4 February 2022

RE: LDA2021/0300 – 6 – 8 Western Crescent, GLADESVILLE – Response to RFI letter

Figure 5: Bin movement for residential and community (Source: Waste Audit)

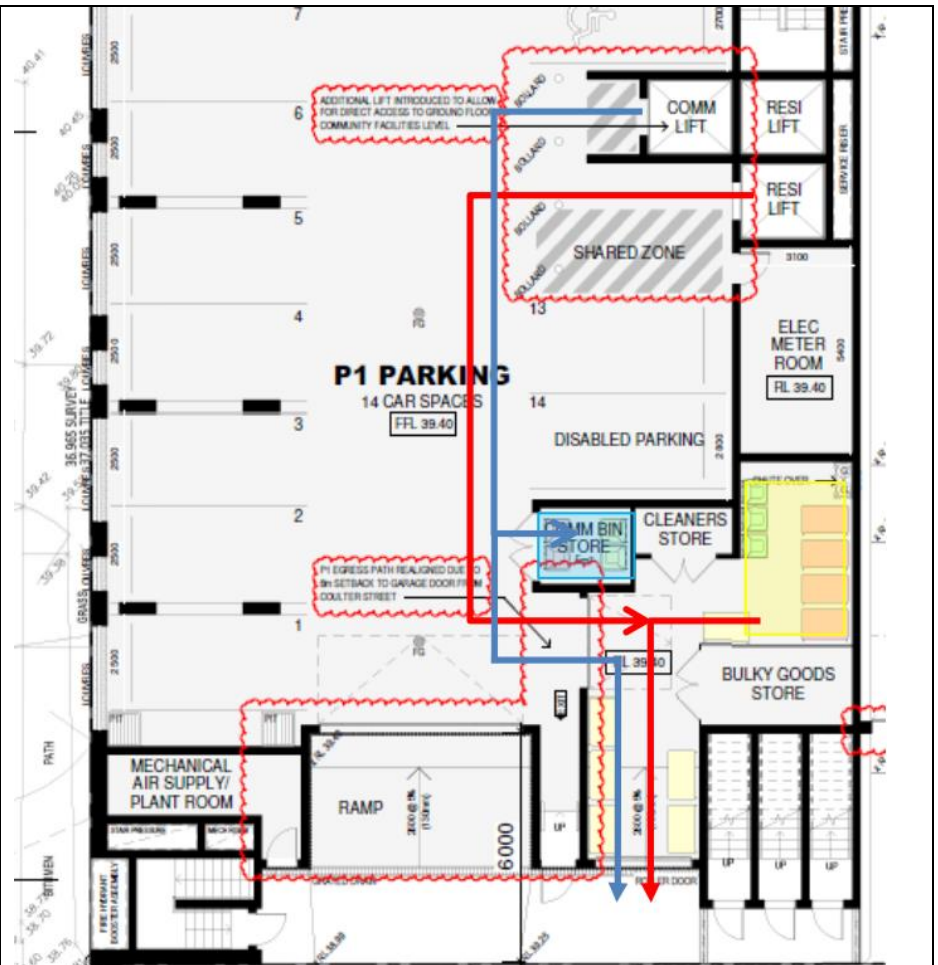
Matters	Applicant response
	<p>TTPP conclude their statement noting that the amended proposal addresses Council's key traffic and parking concerns.</p> <p><u>Public Domain</u></p> <p>The subject application does not propose any modification to the approved footpath widths under LDA2016/0058. The amended application enhances the public domain on the Western Crescent and Ross Street frontages by providing eight (8) additional street trees following the recommendations of the UDRP. Further, a continuous street awning has been provided on the Coulter Street frontage in accordance with Section 3.1.7 of the DCP to facilitate activation of this frontage. All three street frontages have been addressed through the amended application.</p> <p>Additional public domain works may be conditioned as per the previous approval.</p> <p><u>Waste</u></p> <p>An Amended Operational Waste Management Plan (WMP) has been prepared by Waste Audit which accompanies this letter. Waste and recyclables are stored in the bin storage rooms on Level P1. The residential and commercial (community facility) bin rooms have been separated in accordance with the advice provided by Council. Each habitable floor will be equipped with a service room with garbage chutes for general waste. The service rooms on each floor will also have 1 x 240L bin that will contain the holdings of mixed recycling, which will be transported to the bin storage rooms once at capacity.</p> <p>All bins will be presented for collection by the building contractors/cleaners on their designated collection days. On the designated collection days, bins will be collected from the waste enclosure on the Level P1 and brought to the temporary bin store. The collection vehicle will be stationed on Coulter Street and have access to the residential waste enclosure through a roller door connecting the street and the waste storage area, minimizing the space the contactors have to travel to collect the waste.</p>

At the meeting with Council via Zoom on 2 December 2021, Council agreed to allow for the 10.8m garbage collection vehicle to be stationed on Coulter Street due to constraints for forward entry and exit from the development. Council contractors will be responsible for rolling out bins to the rear of the waste truck and returning the bins to their respective waste storage rooms post service. As per discussion with Council, it is considered the best scenario is to collect the waste from Coulter Street due to the waste truck being unable to exit in a forward direction from the carpark.

This is considered a reasonable waste solution for the site. The accompanying swept path plans prepared by TTPP demonstrate that maneuverability into and out of the site is manageable during collection by Councils 10.8m truck. The opening in the boundary wall allows for a sightline up Coulter Street and into the site when entering to provide safe throughfare. An extract of the swept path diagrams is provided in Figure 4 above.

For the community facility, the bins will be accessible via the lift leading to the Level P1 car park, where a separate bin room will hold bins for general waste and mixed recycling. These will be collected once a week by a private contractor.

Figure 9: Extract of Public Domain Sheet 1 (Source: Site Design + Studios)

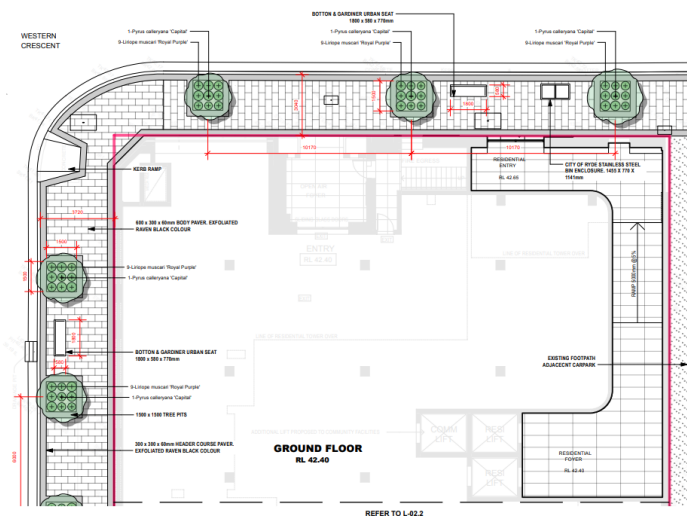
The amended design provides eight (8) new street trees along the Western Crescent and Ross Street frontages following the recommendations from the UDRP. Three new trees are provided on Western Crescent and five are provided along Ross Street. The configuration of these trees is outlined in the Landscape Plan extracts below.

The additional street trees provide articulation at street level along these frontages and are beneficial to the Gladesville Town Centre streetscape.
